Grimes Planning and Zoning Commission Agenda

Grimes Planning & Zoning Commission January 2, 2024 In Person at Grimes Community Complex, 410 SE Main Street, Room 202

RE: Hope Plaza 3 Site Plan

RE: Grimes Public Works Site Plan Amendment

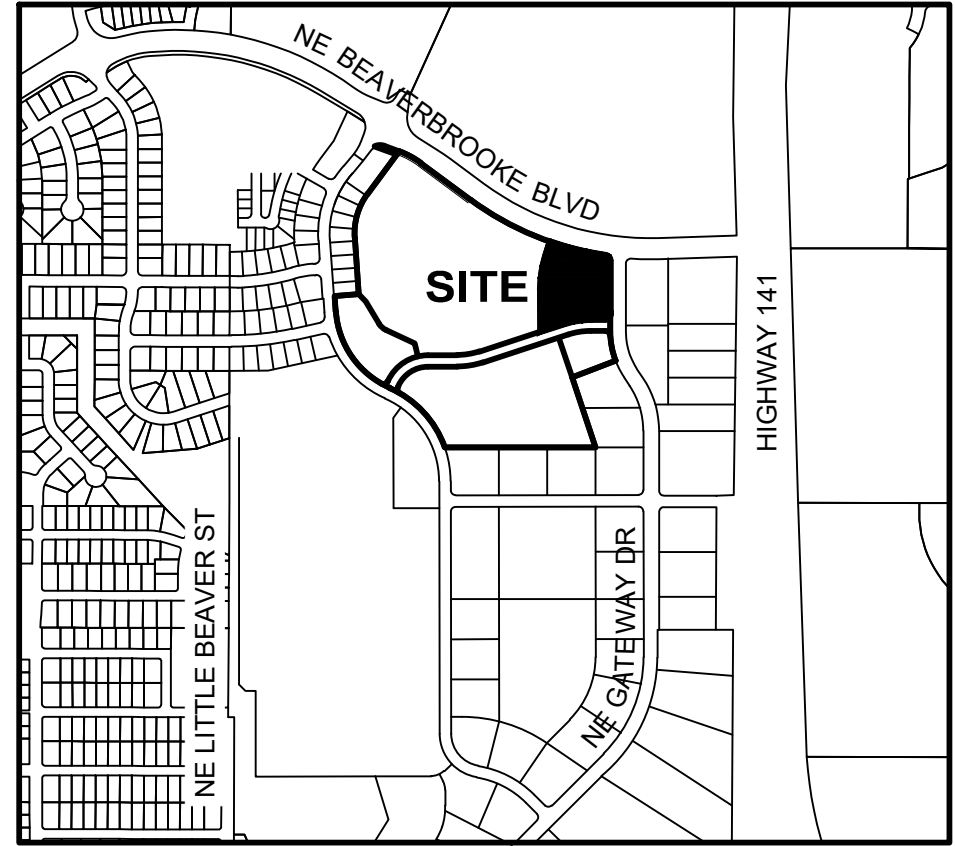
- ~~5. Please provide easement to accommodate future improvements to the intersection. See exhibit below.~~
 - ~~a. Provide minimum 3' easement along Beaverbrooke.~~

- ~~b. Please provide an area of 5' x 5' outside of the sidewalks at the SW corner of the Beaverbrooke/Gateway intersection for future traffic signal. The easement at the corner should be expanded to accommodate a 5'x5' area for the traffic signal within the easement and a portion of the sidewalk.~~

1 EAST ELEVATION
A2.2 SCALE: 1/8" = 1'-0" @ 36x24

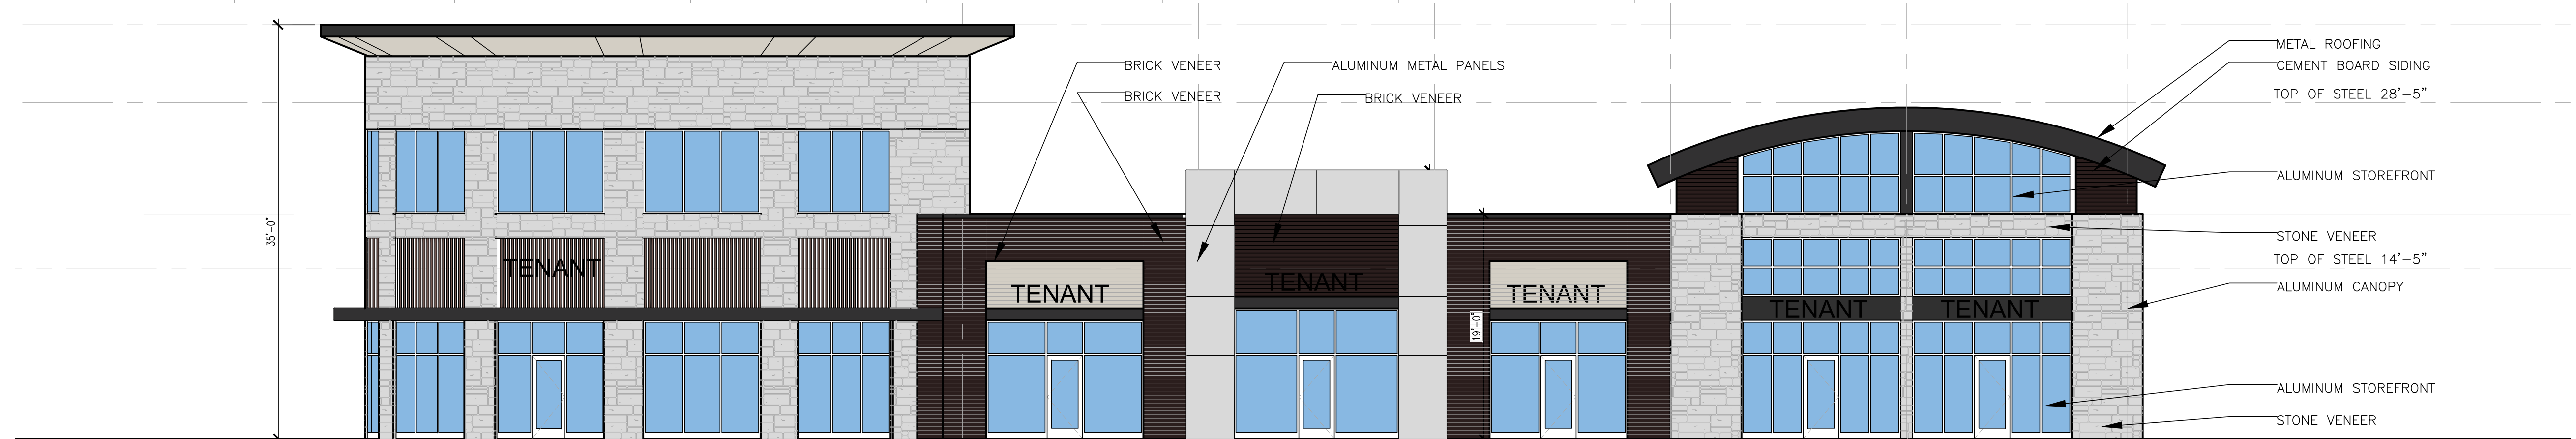
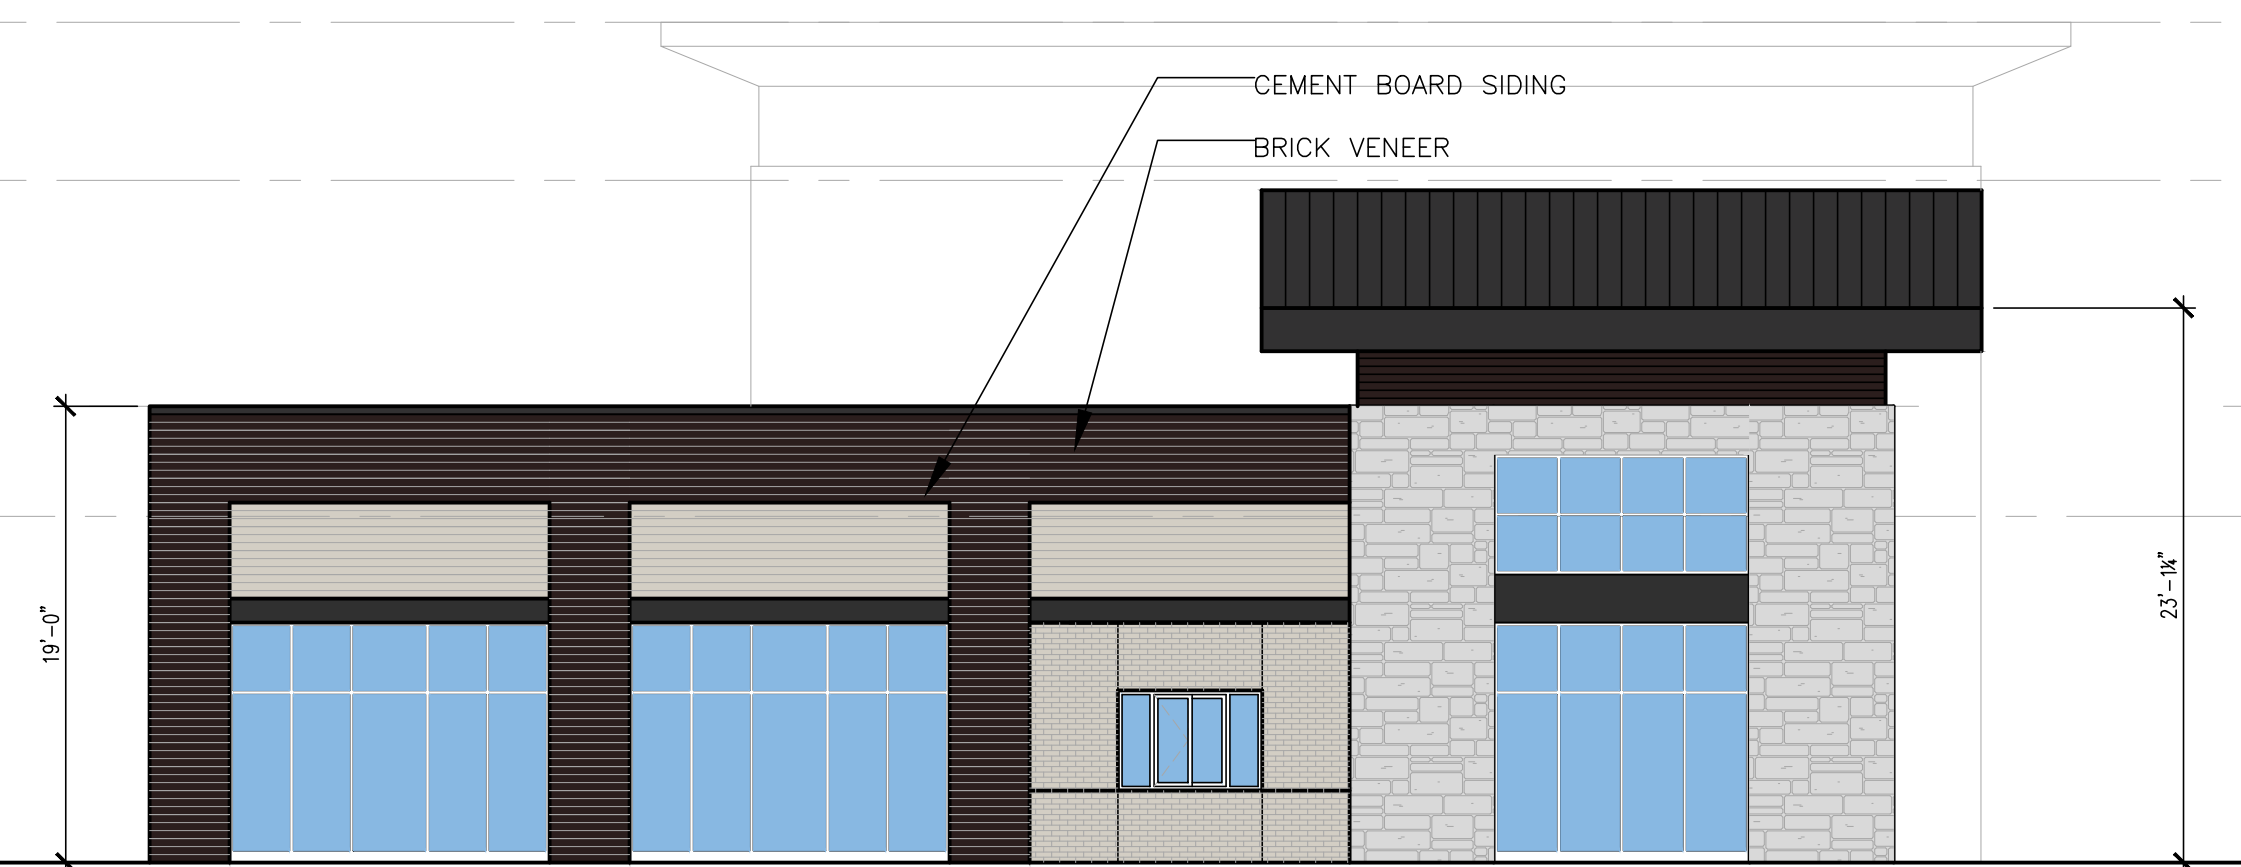
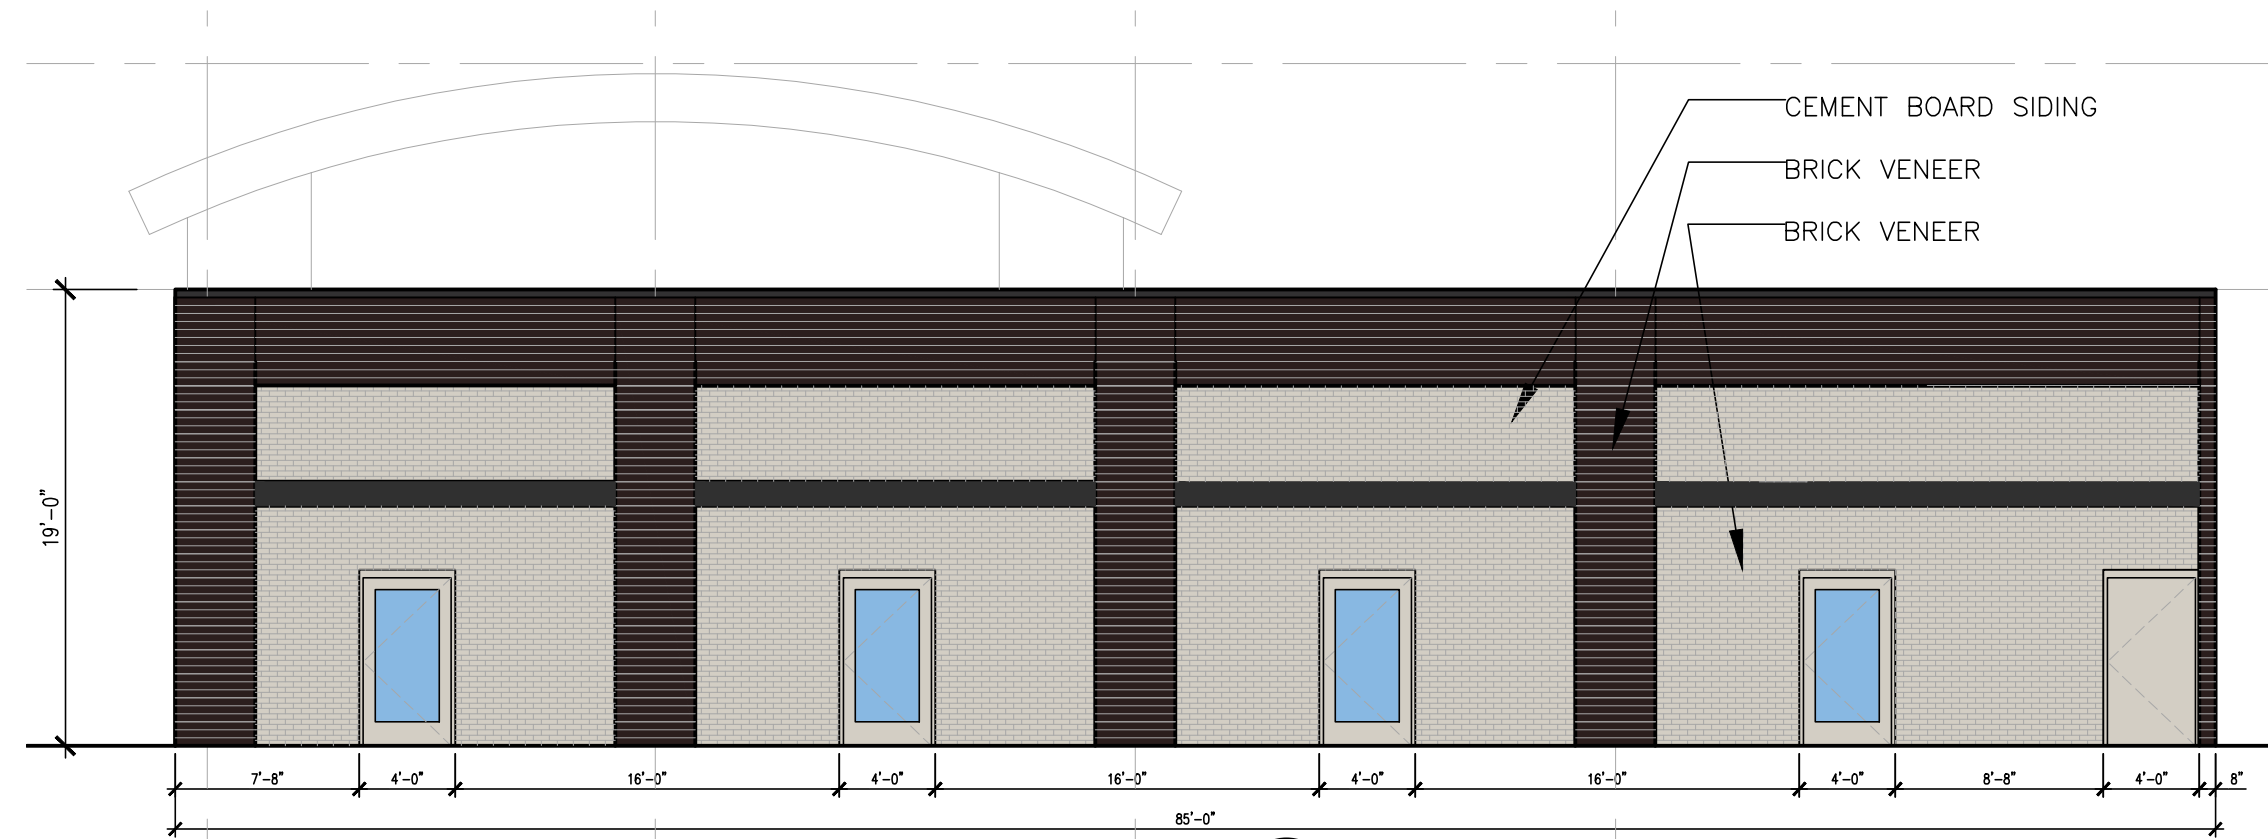
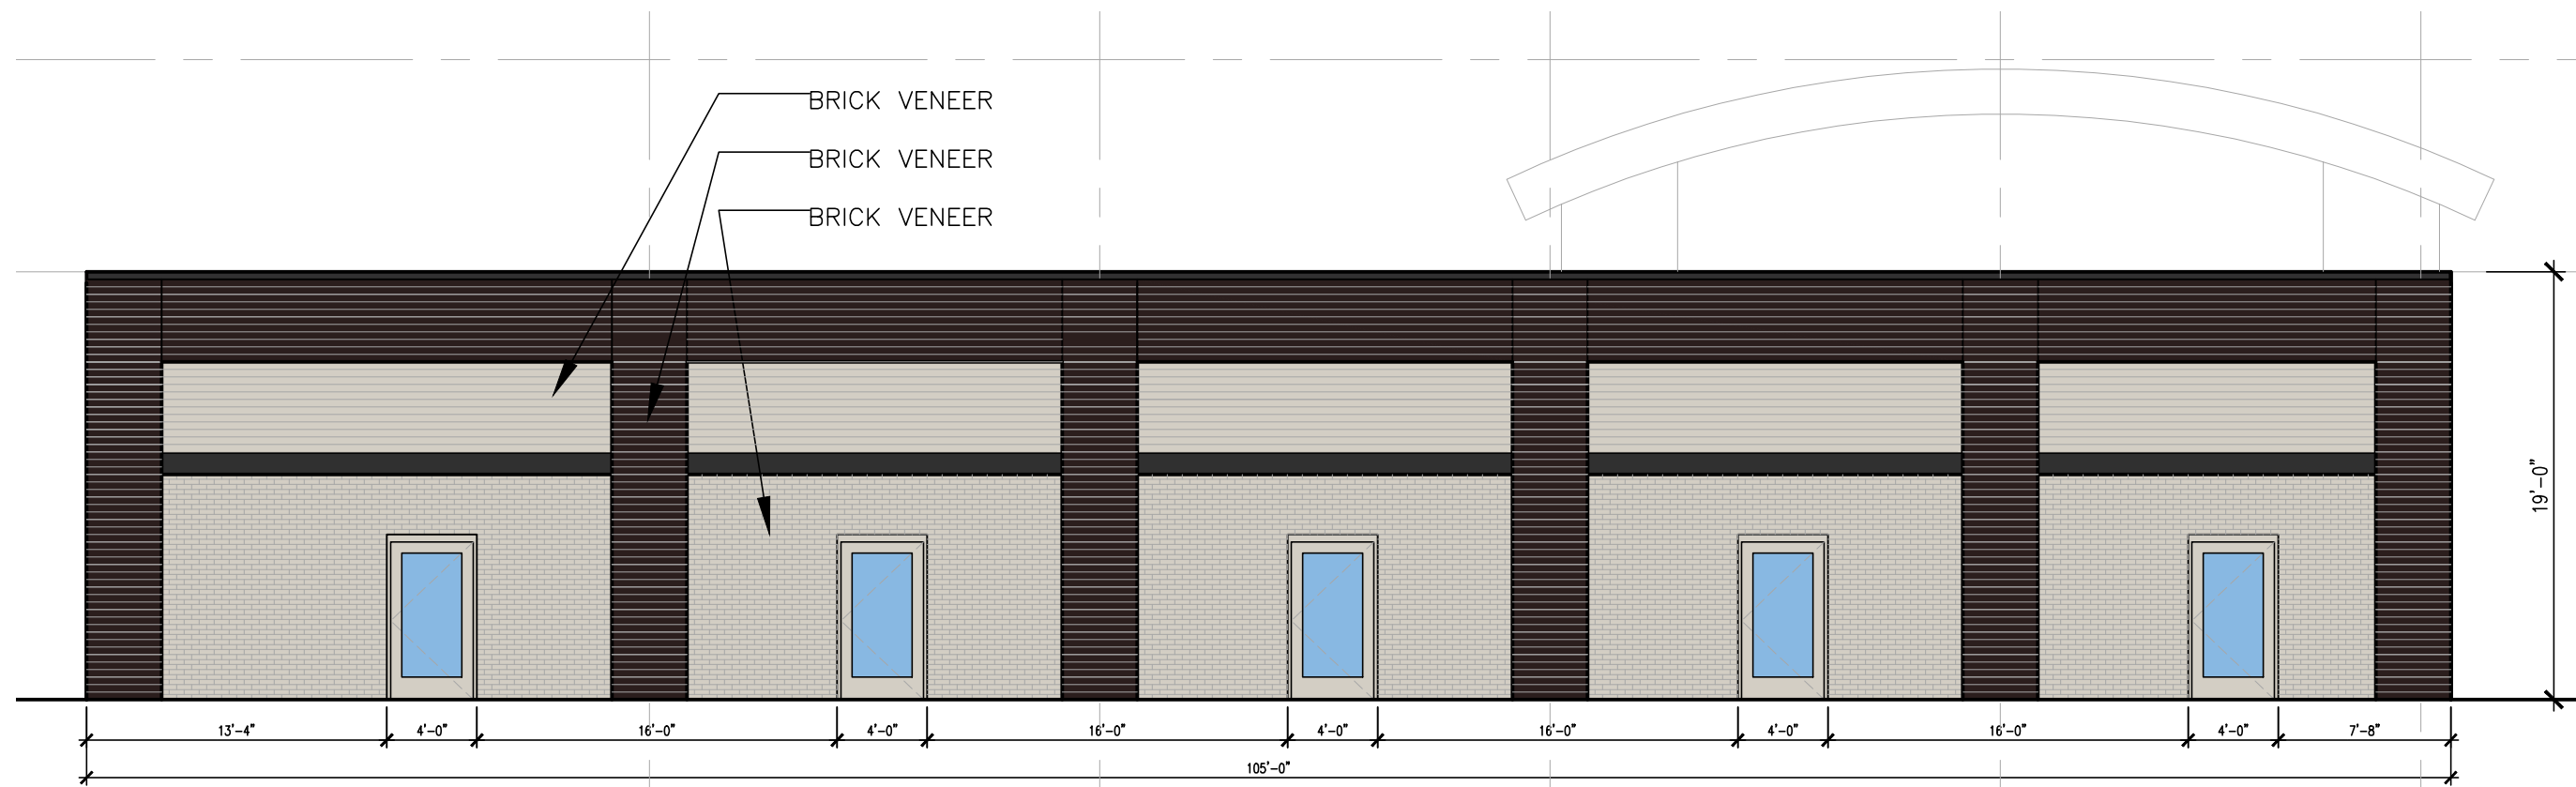
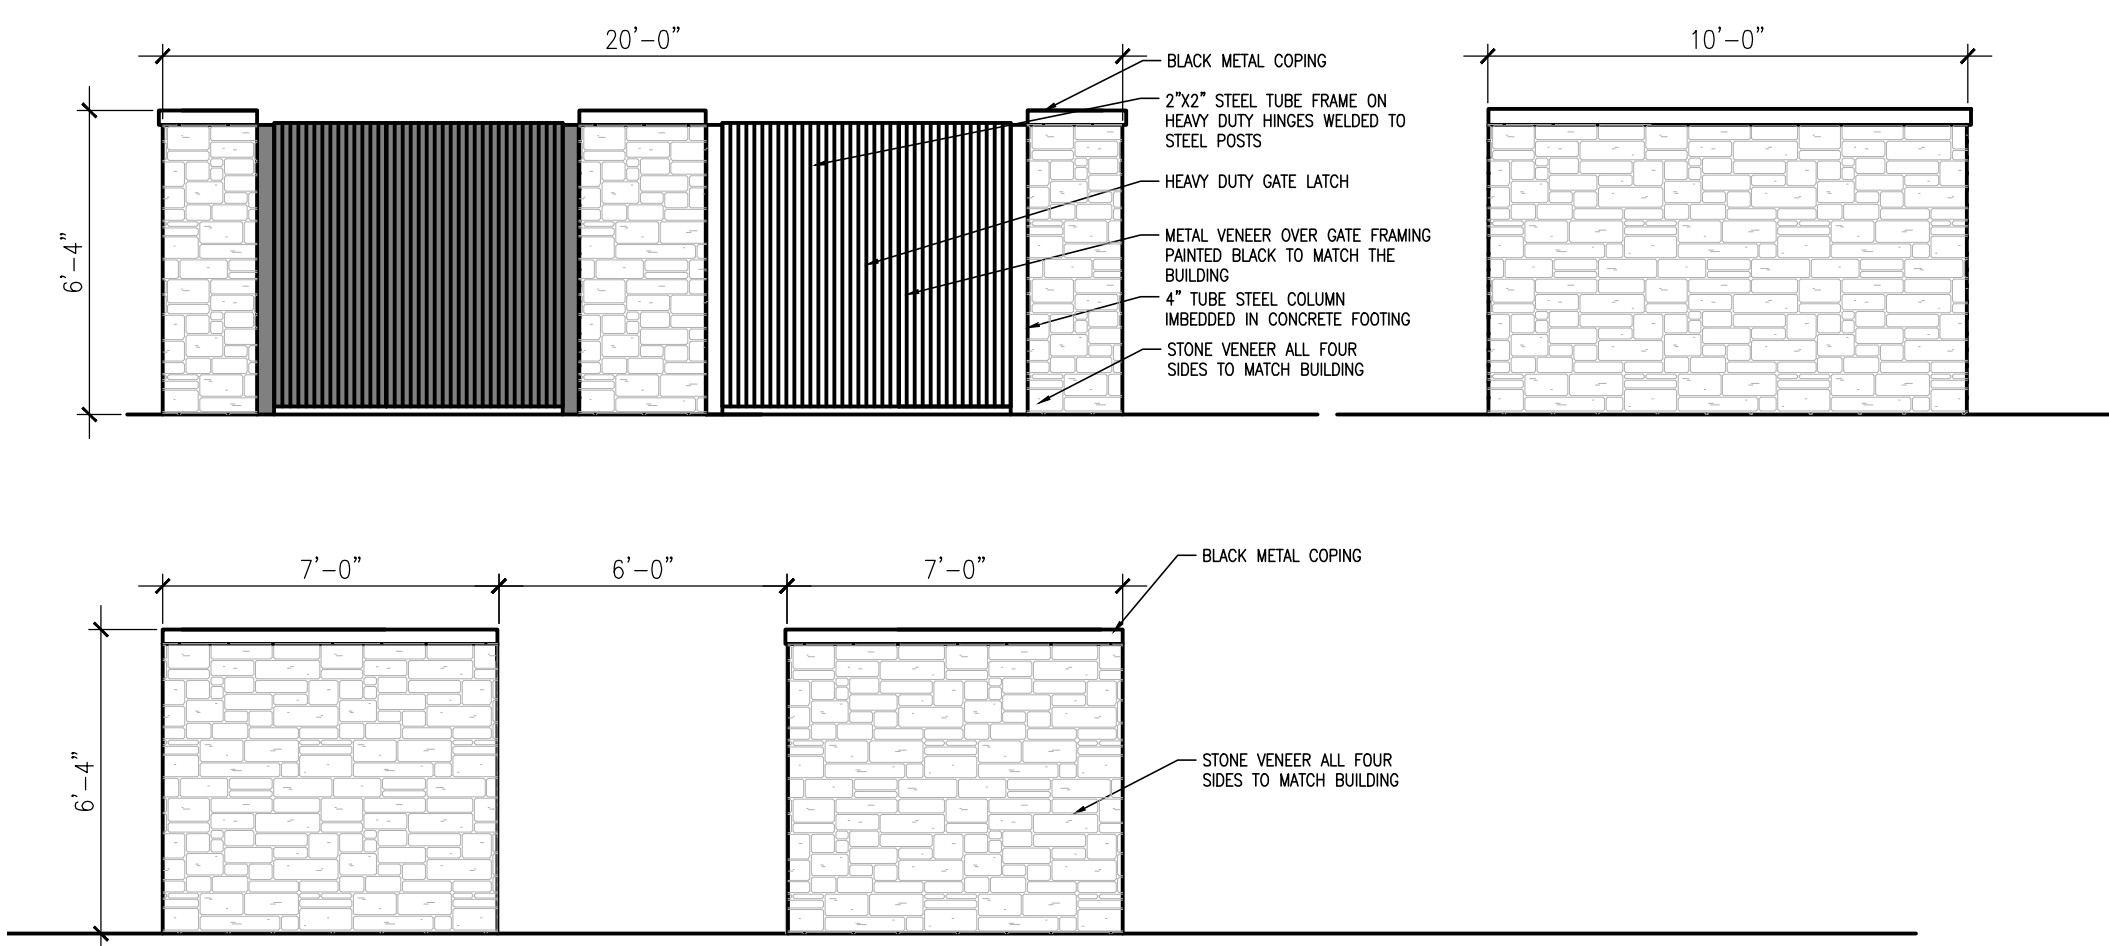
1. ~~Provide elevations for the rear of the building.~~
2. ~~Label building materials on the elevation drawing.~~
3. ~~Provide building material percentages. A minimum 75% of all facades exclusive of doors and windows shall be brick/stone or similar concrete or masonry material. The front and sides do not meet the 75% masonry requirement. Please revise. In review of the PUD, this site is located within the Commercial Central area where the permitted primary building materials are brick, stone, or masonry. Nichiha and metal would not be considered primary material but can be used as part of the other 25% of the building materials.~~

6. ~~Provide lighting cut sheet. Please provide building lighting cut sheets.~~
7. Update the building elevation to show the retaining wall at the rear of the building and label the proposed material and color of the exterior face of the wall and railing.

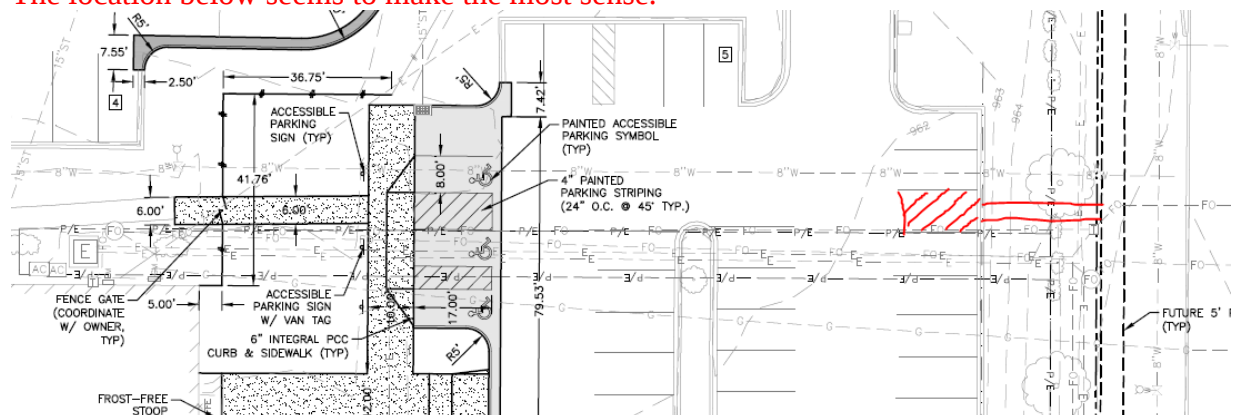
1. The sidewalk can be shown as future. Staff will draft a sidewalk agreement to ensure future construction in the event the City sells the property. Usually, we offer two different options for property owners (see below). However since the City is the current applicant, option B may make the most sense. **Attached is the draft agreement for reference.**
 - a. Provide the City with the cost of the sidewalk for the City to construct with the SE Destination Dr improvements.
 - b. Property owner can construct the sidewalk after the SE Destination Dr improvements are completed upon notice from the City.
2. **Please show a future sidewalk connection from the public sidewalk to the building. The location below seems to make the most sense.**
